# Providence City Plan Commission

July 18, 2023

## AGENDA ITEM 1 ■ 108-110 WATERMAN STREET

View of building and rendering

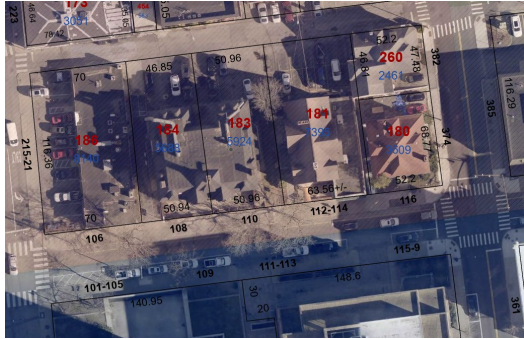
The applicant intends to maintain a roof deck that will be accessible to residents, providing seating and a gathering space. The DPD is concerned that the space could have a negative effect on the surroundings as the applicant intends to develop a proximate building with a rooftop gathering space at 116 Waterman Street. The cumulative impact of these gathering spaces could have a negative effect on the surroundings through generation of noise and the potential of residents to disturb other properties. It is the DPD's opinion that a roof deck should not be permitted.

The current building on the property is a distinctive looking structure. It is not in a local historic district. But it is in the College Hill National Register Historic District. It is described as a Queen Anne/Late Victorian structure, constructed in 1877. The DPD is of the impression that the demolition of this structure could have an adverse impact on the national register historic district and the built environment of the city. However, we feel that more study into the significance of the building should be performed prior to formulating a firm opinion.

The CPC should take no action on the request for a dimensional adjustment pending further study.

The CPC should continue the matter to the meeting of September 19, 2023, pending further study into the impact of the demolition of the building on the built environment and further findings of consistency with the comprehensive plan.
